January 13, 2026

PWS ID: 25200626
Racine Waterworks
MC - Racine County

Subject: Sanitary Survey Report and Notice of Noncompliance of the Racine Water System

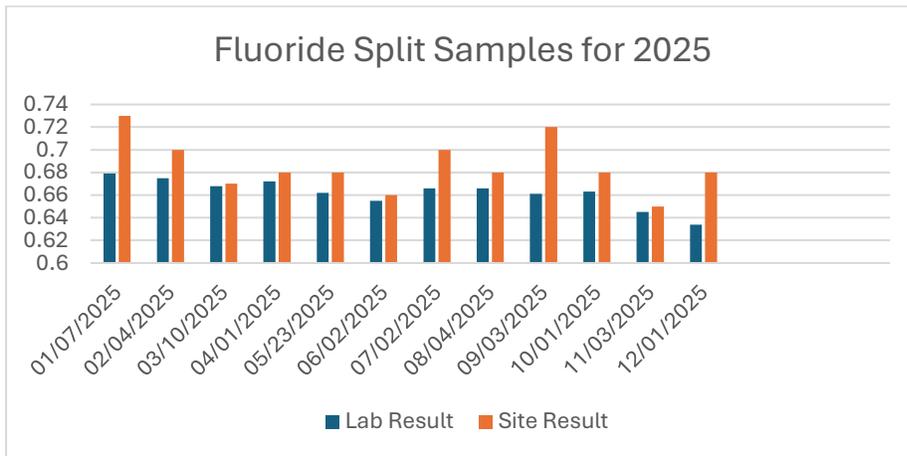
The fluoridation program for the Racine water system has an excellent history of sample submission for the last 12-month period. All monthly split samples were collected and were submitted to the State Lab of Hygiene, as required. The average residual for the most recent twelve monthly split samples submitted in the last year was 0.66 mg/L. This average is within the desirable range of 0.6-0.8 mg/L. The operators’ fluoride split sampling results have compared favorably to those obtained by the State Lab of Hygiene. This indicates the operators are doing a good job when performing the fluoride residual tests and that the testing equipment used to run these analyses is functioning properly. The operators are encouraged to keep up the good work with the fluoridation program. The graph below shows the results of the fluoride split samples that were sent to the State Lab in 2025.
